S4.55

Lot 3 & 4 DP271196

315 The Entrance Road &
24 & 26 Gallipoli Road Long Jetty

87 Seniors Living Apartments

Drawing
GROUND FLOOR PLAN

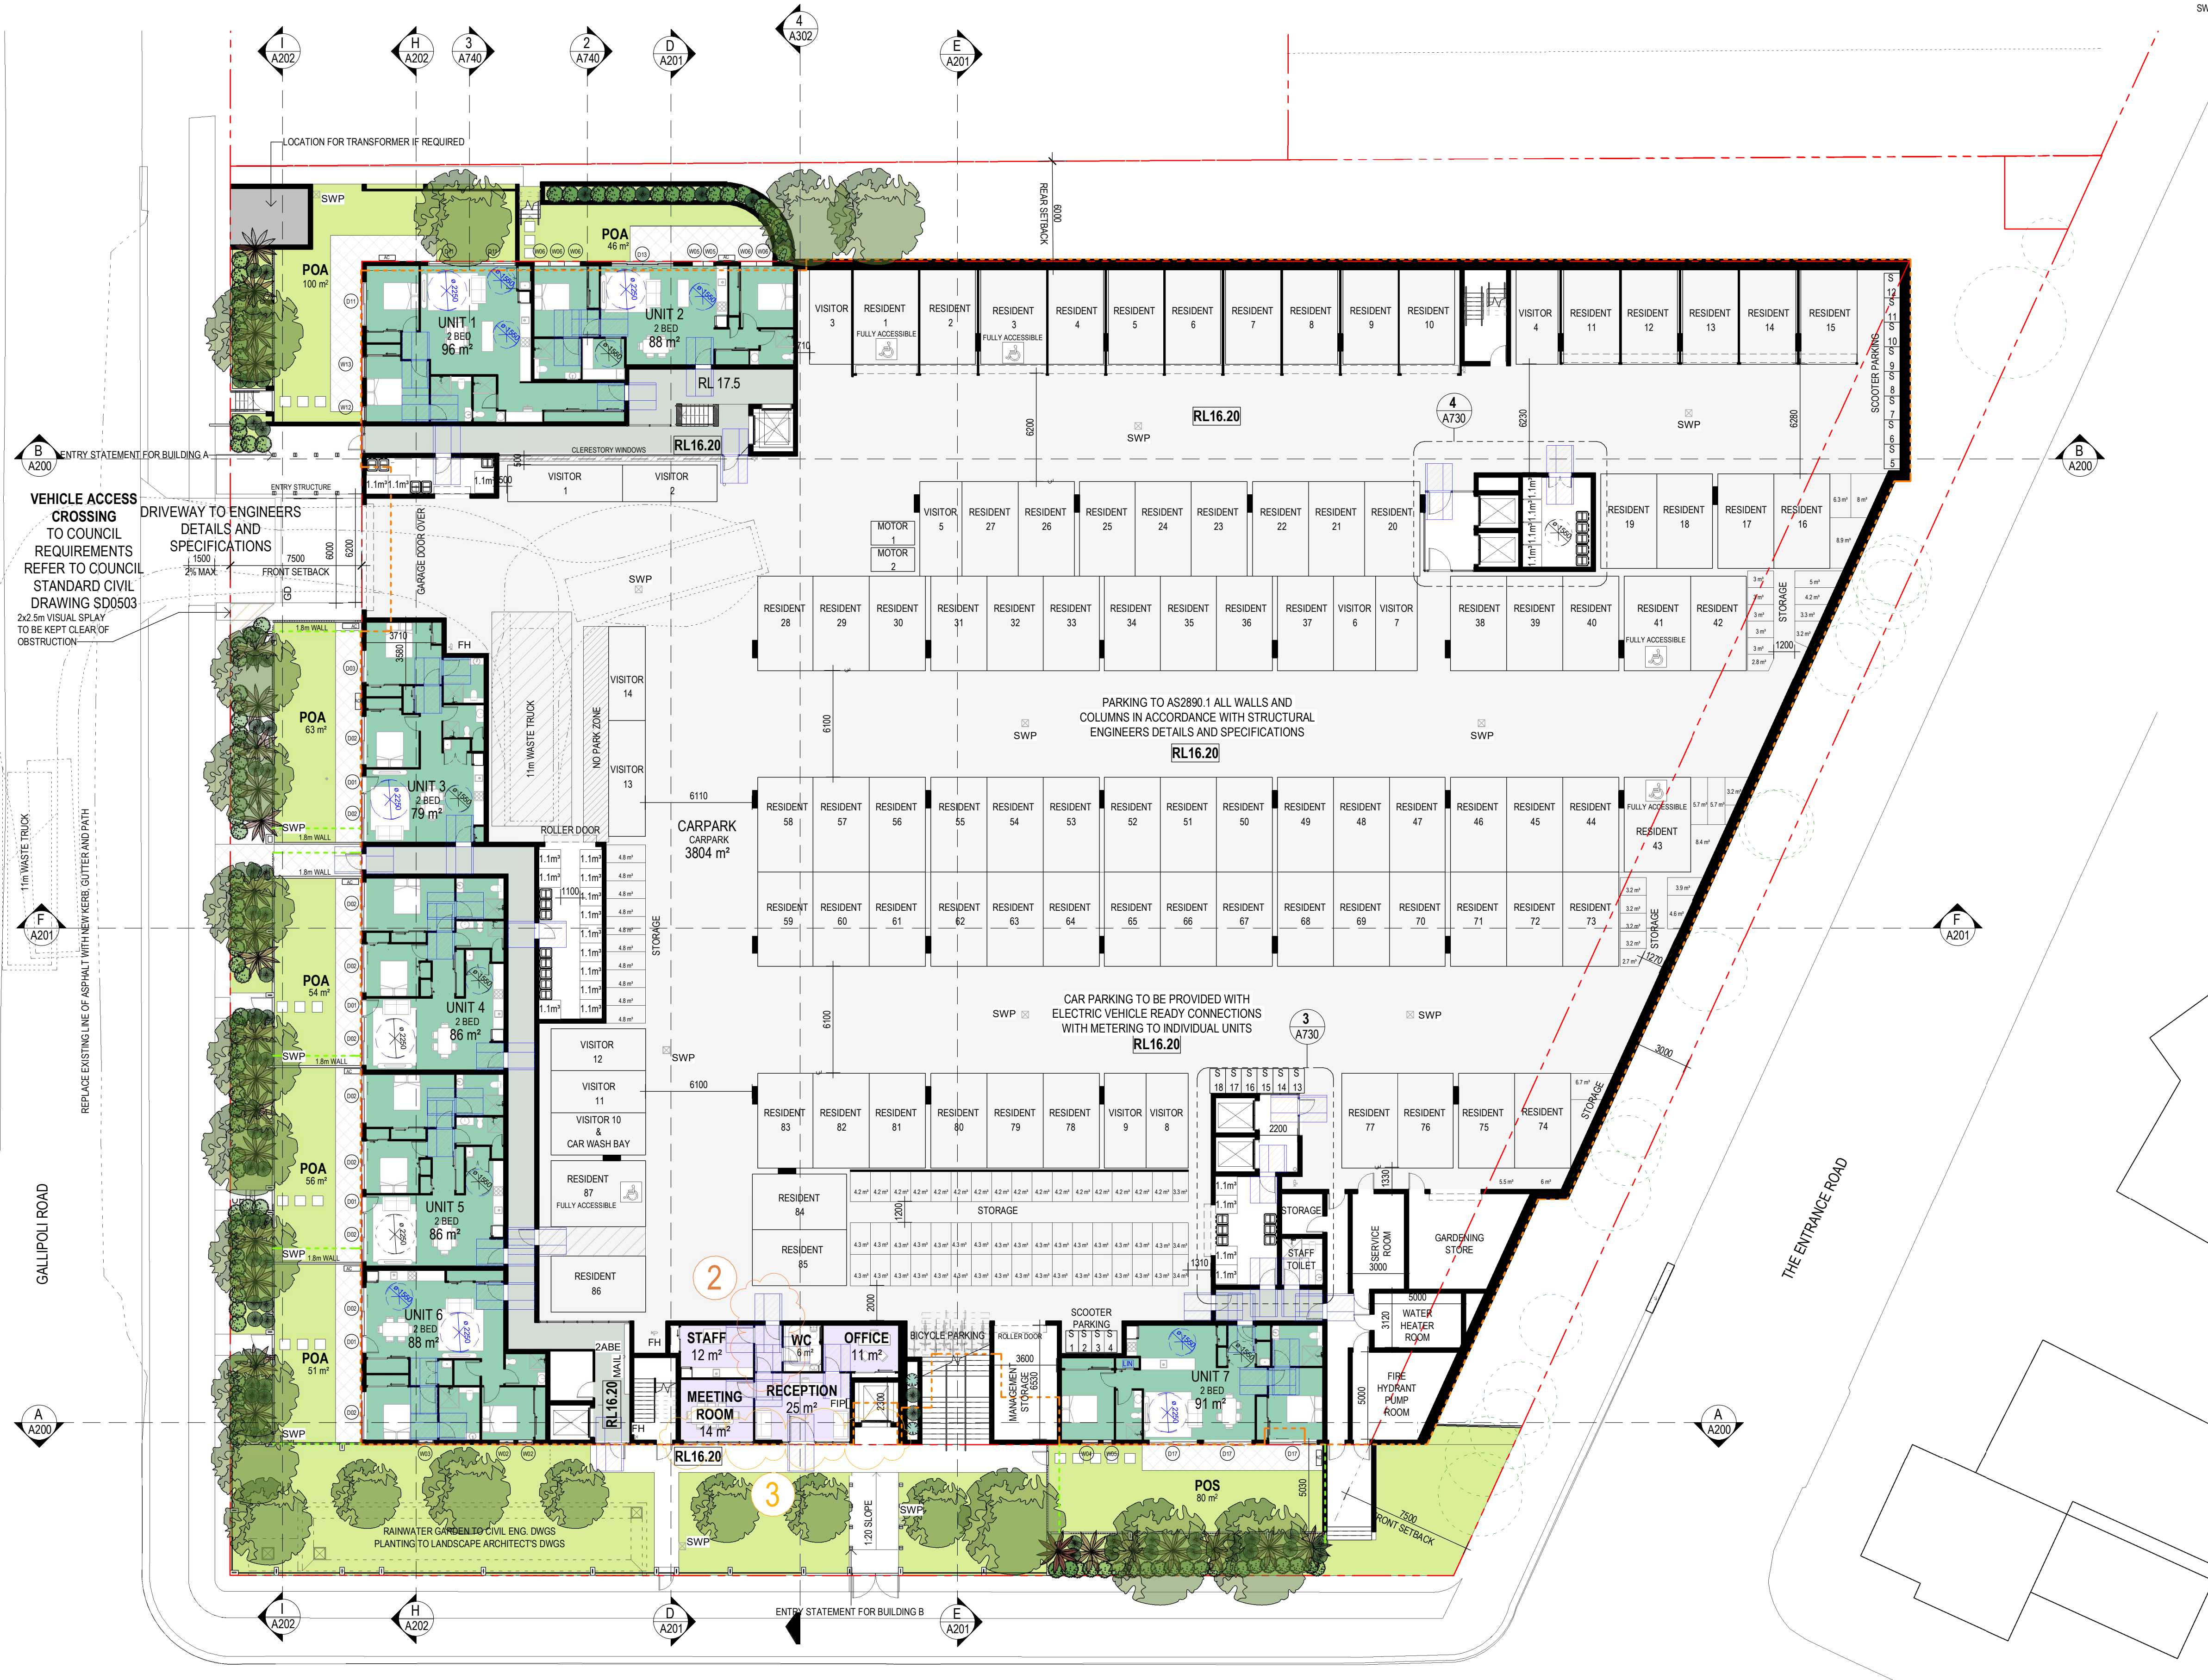
S4.55 REVISIONS RFI #4

- Screening for privacy
- Airlock provided into Staff area
- Curtain wall and entry door updated

Drawing
LEVEL 2

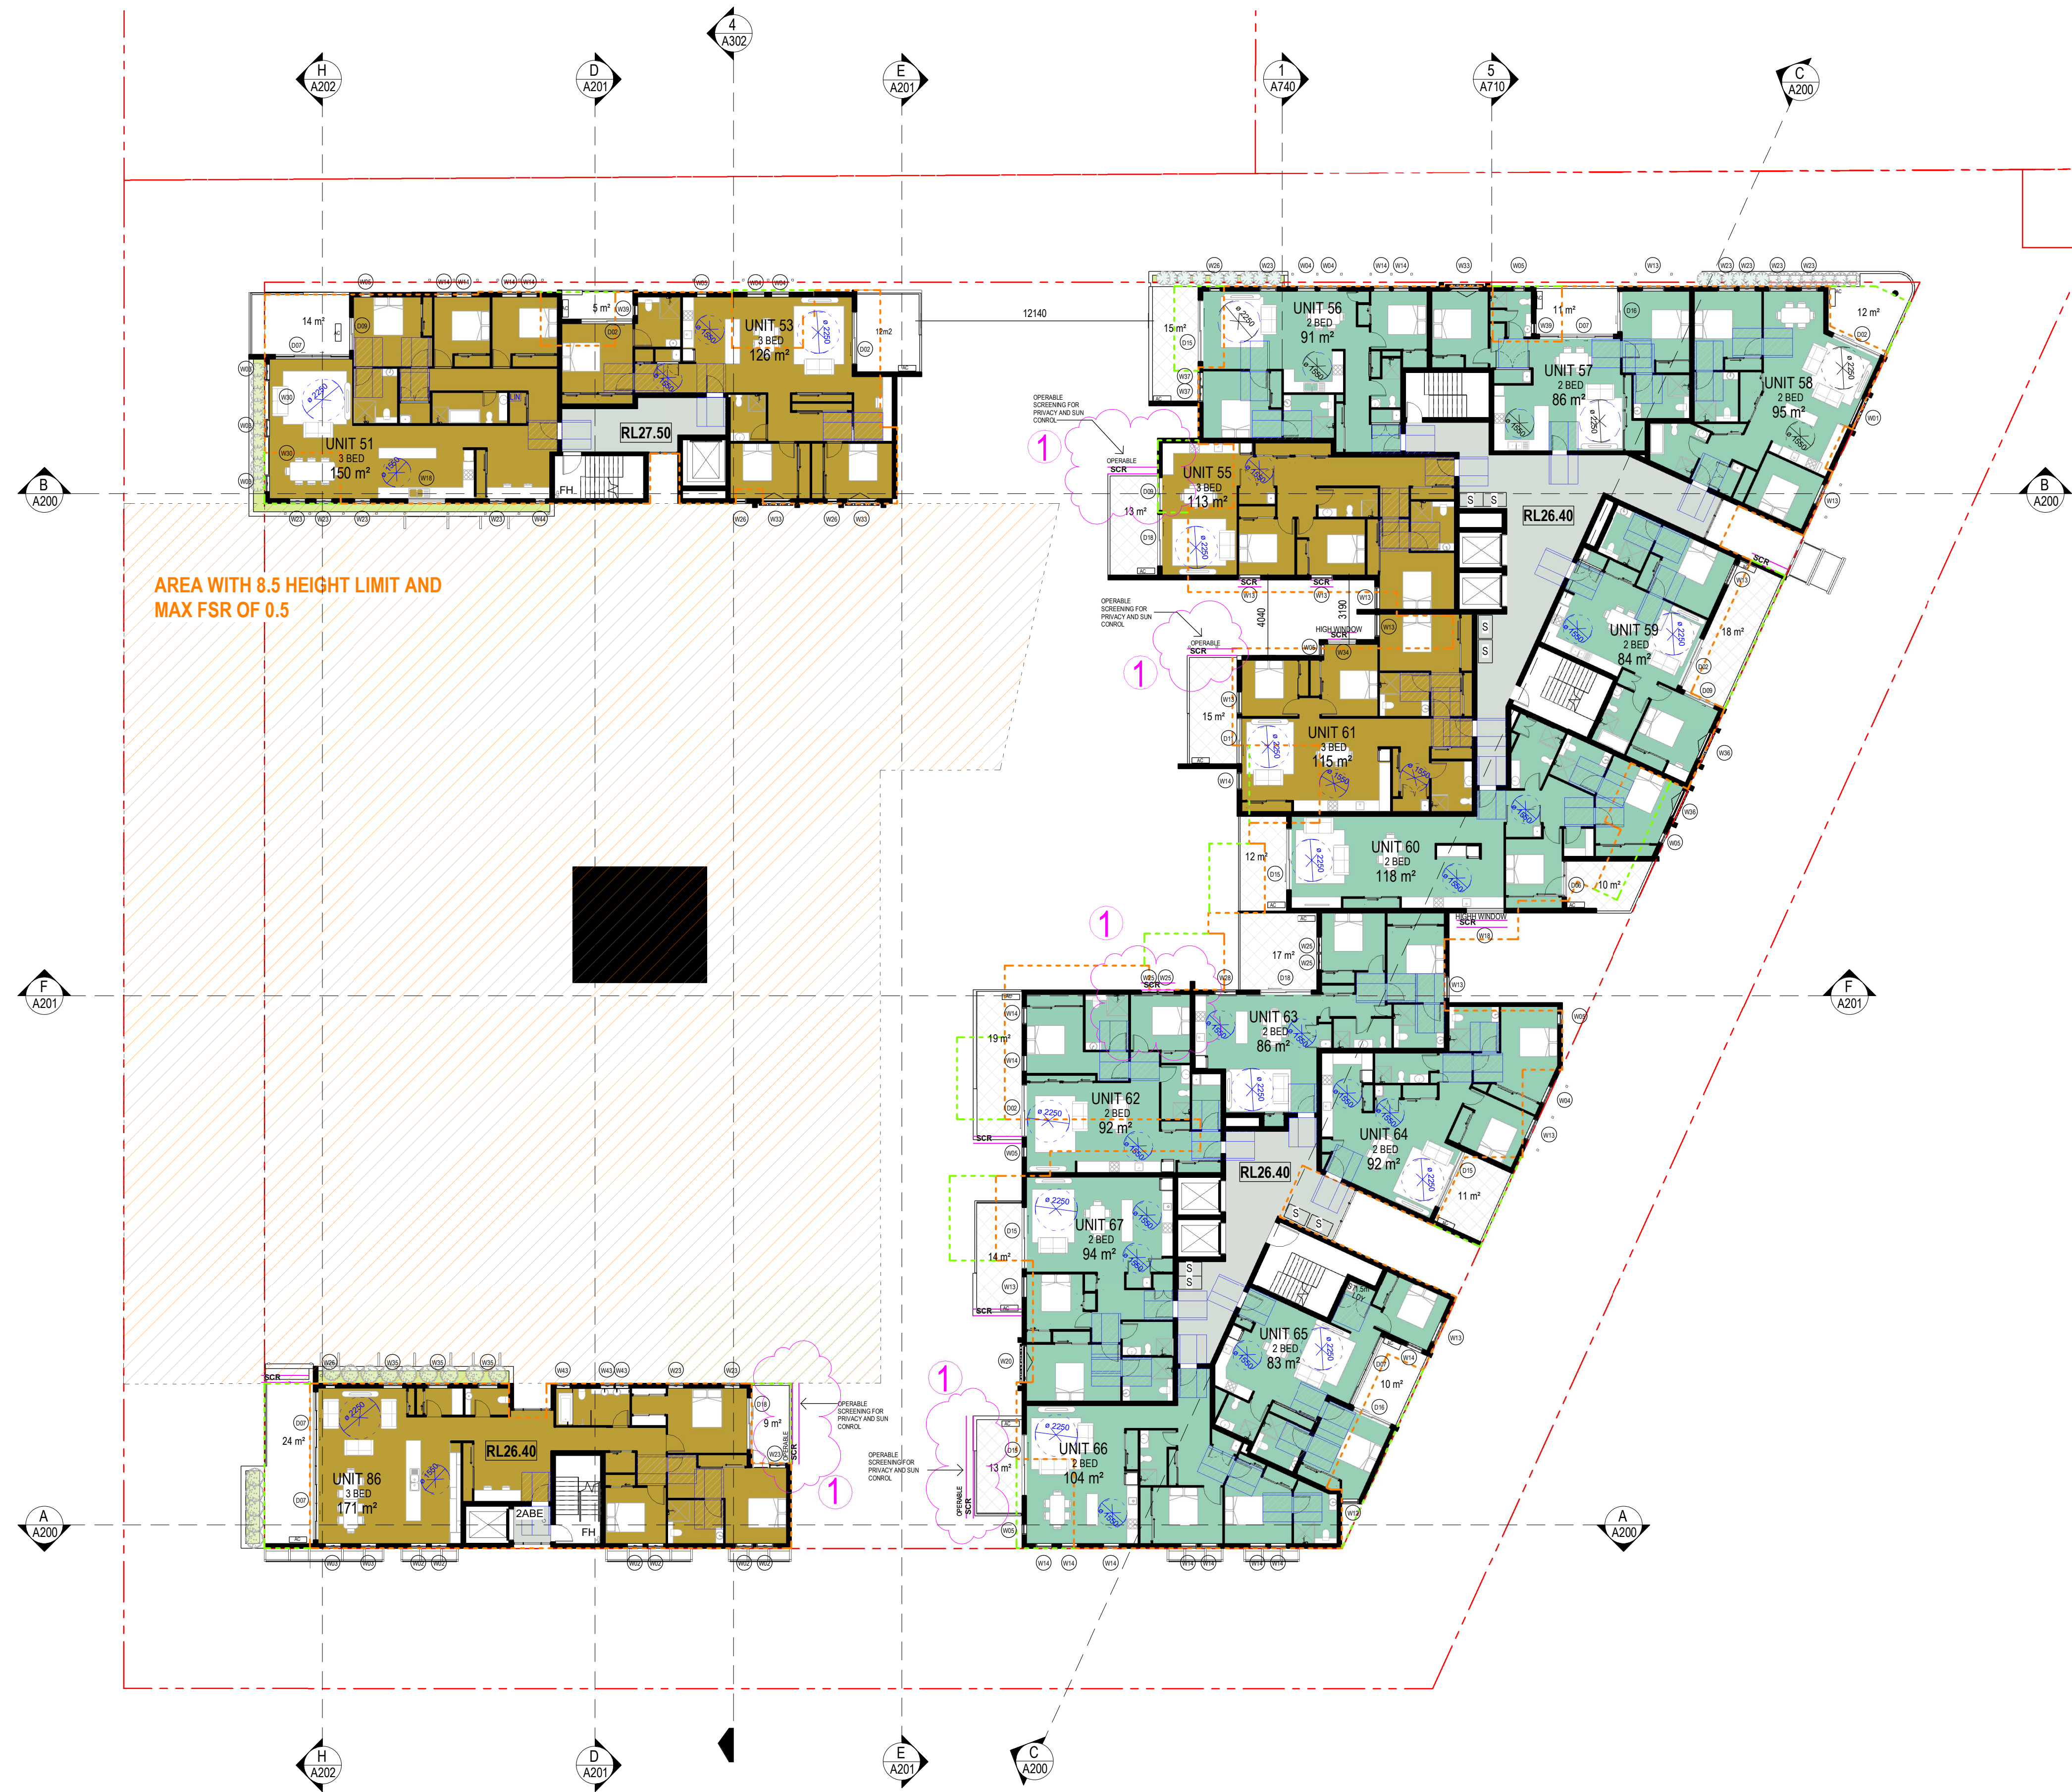
S4.55 REVISIONS RFI #4

- Screening for privacy
- Airlock provided into Staff area
- Curtain wall and entry door updated
